SUPPLEMENTAL INFORMATION
IN RESPONSE TO CEC DATA ADEQUACY REQUEST

APPLICATION FOR CERTIFICATION
STARWOOD POWER-MIDWAY, LLC PEAKING PROJECT

Subject: Starwood-Midway Project (06-AFC-10)
Supplemental Information in Response to CEC Data Adequacy Request
URS Project No. 27656131.00400

Figure 5.13-2A

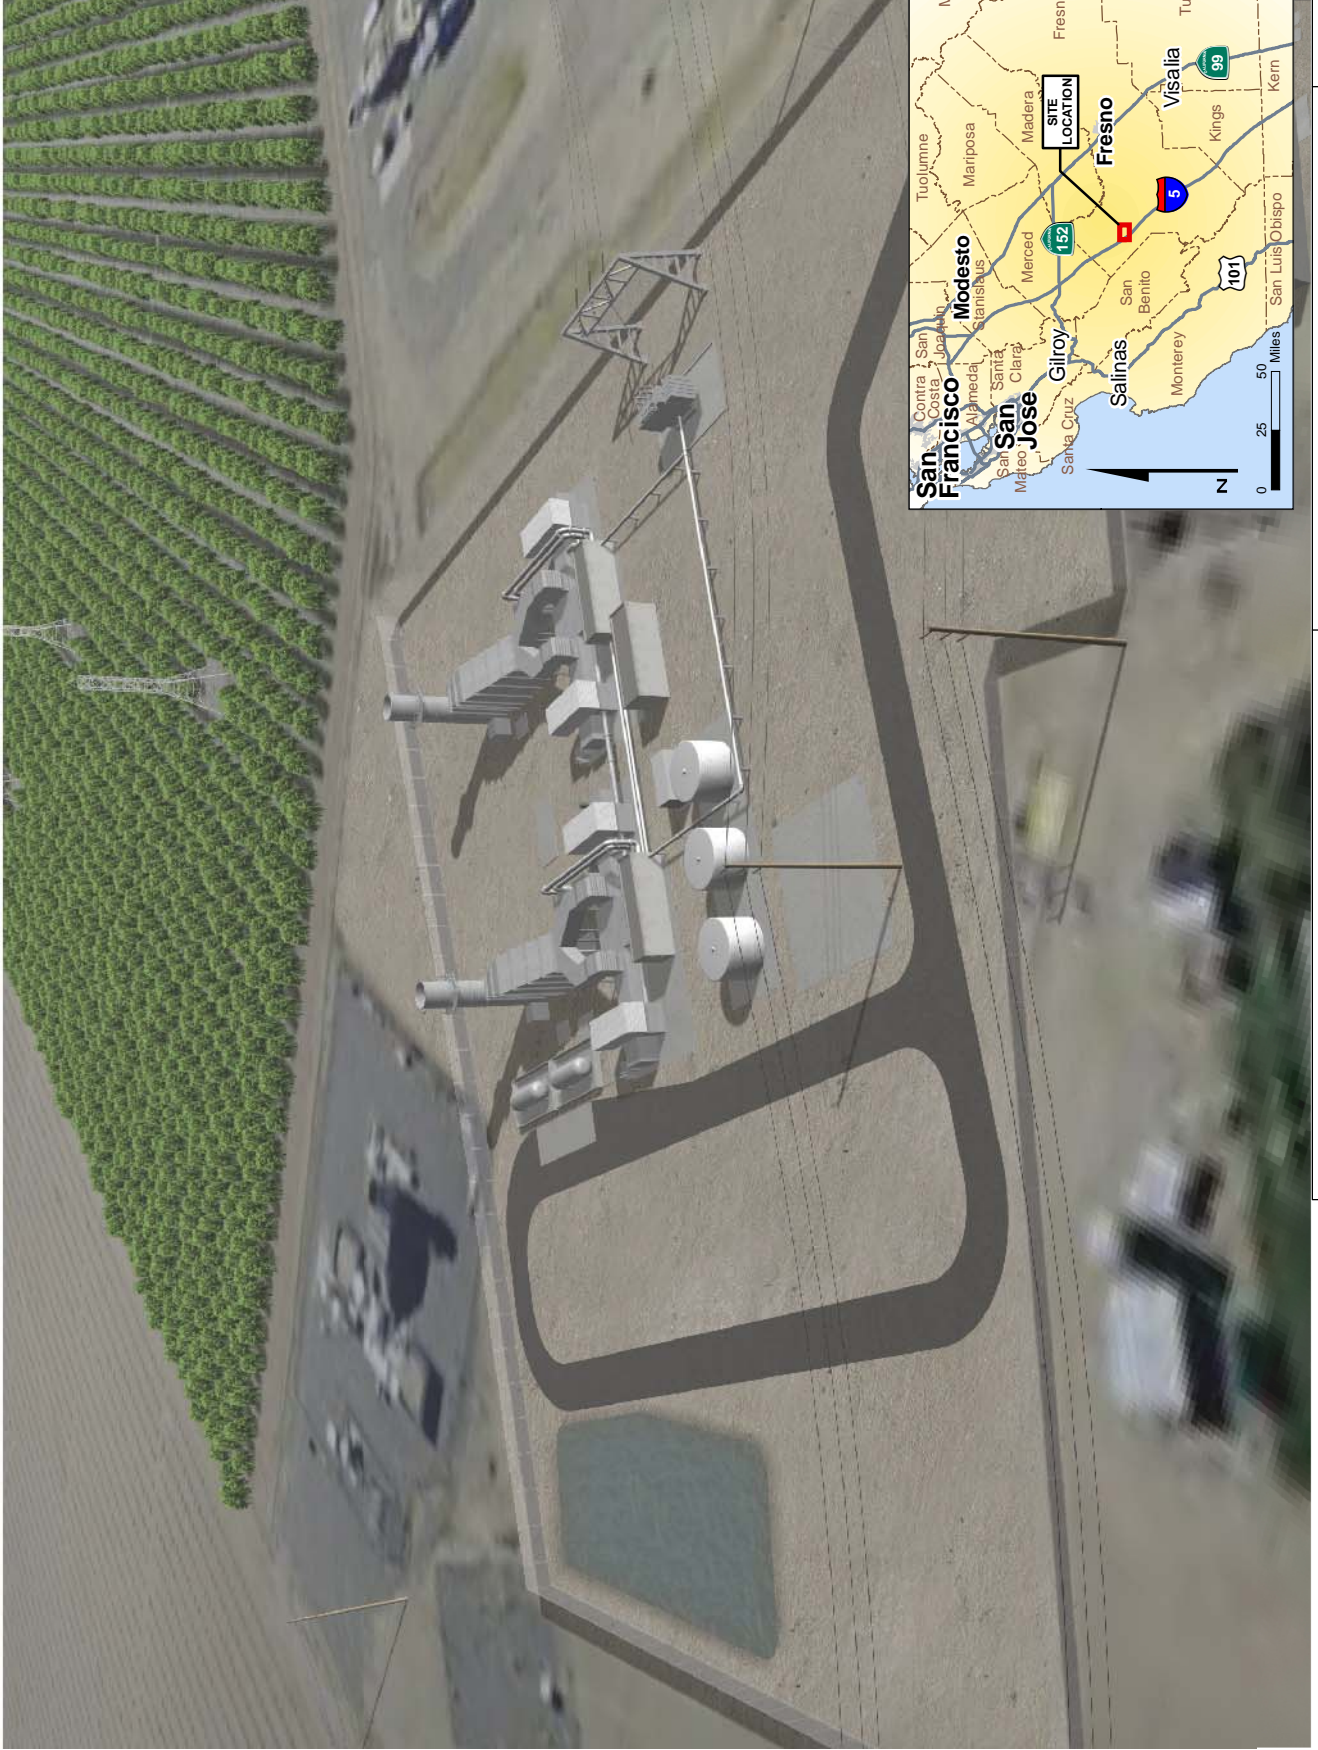
Data Request 8 Rev: Please provide full-page color photographic reproduction depicting the visual appearance of the site prior to construction and a full-page color simulation of the site after construction. The AFC includes the necessary figures in half page format. Please provide Fig 5.13-2 and Fig 5.13-13 in a scaleable electronic format.

Response: Provided as attachments to this sheet, are the following full-page color figures:

- Figure 5.13-2 (A) – Architectural Rendering of the Project Site Prior to Construction

Please note: Figure 5.13-2 was provided as an architectural rendering and was not developed from a photograph taken at the site. Therefore, Figure 5.13-2(A) is merely an aerial photograph of the site in an effort to show a related overhead view of existing conditions (site prior to construction) at the site.

Figure 3.6-1 CONCEPTUAL INTERCONNECTION ONE LINE DIAGRAM

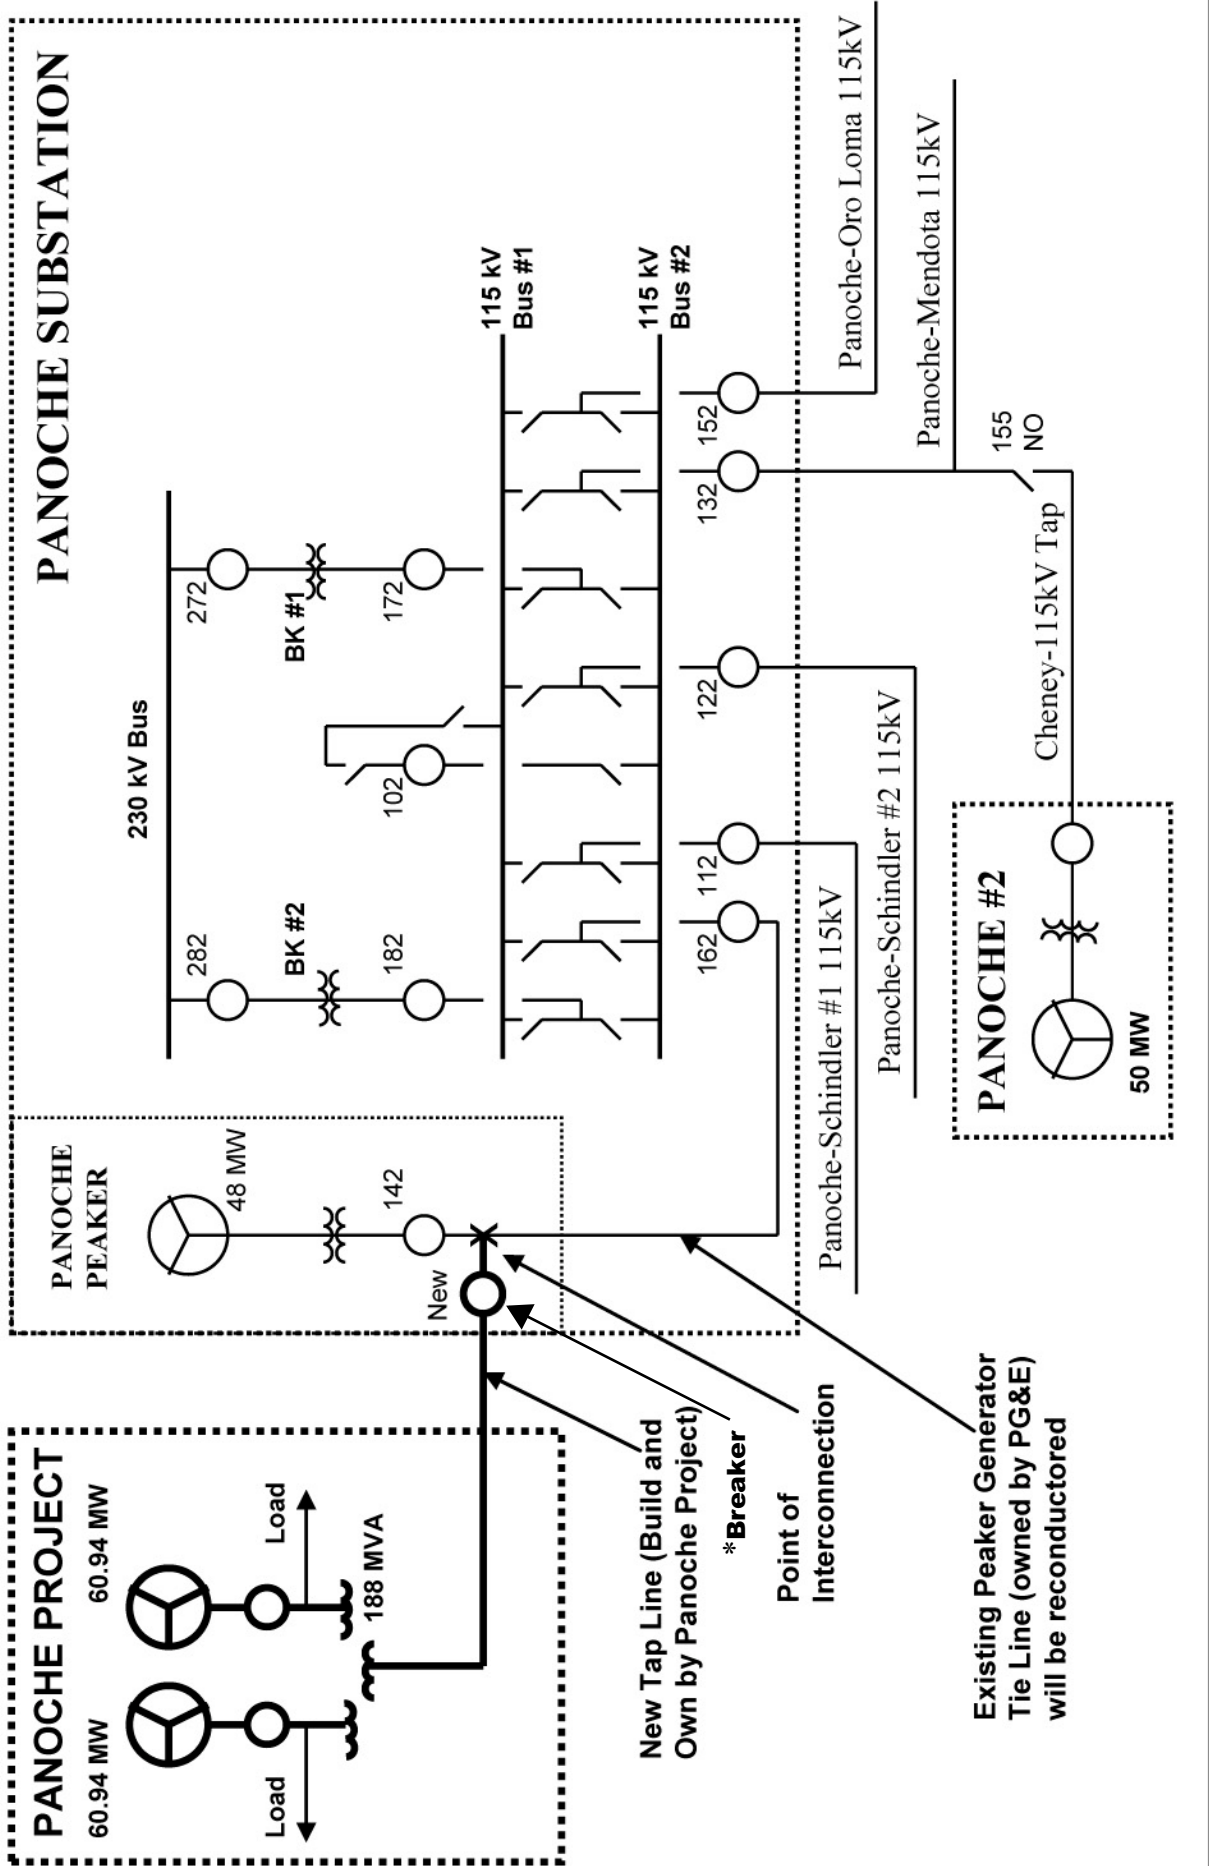
Data Request 19 Rev: Please resubmit Single Line Diagrams (Figure 3.6-1) for the Panoche Substation. The current figure doesn't contain the equipment ratings for breakers, and does not include a disconnect switches.

Response: The proposed Midway project does not include disconnect switches. A description of the breaker equipment ratings is provided below:

Free standing SF6 gas power outdoor circuit breaker, 121 kV, 1200 amps continuous rating, 40 kA, maximum interrupting capability, three cycle interrupting time, weather proof control cabinet, total of two sets of current transformers per bushing, with a ratio of MR 1200:5, accuracy of C800, 125 volt DC control circuits, set of instrumentation to monitor SF6 gas pressure and provide low pressure alarm, gas fill valve per phase to complete filling the breaker with SF6, mechanical operation counter, lightweight air compressor to provide storage air pressure for five closing operations, air storage tank, pneumatic air condensate drain valve, set of cabinet heaters to prevent condensation, ground pads diagonally opposite on the breaker frame.
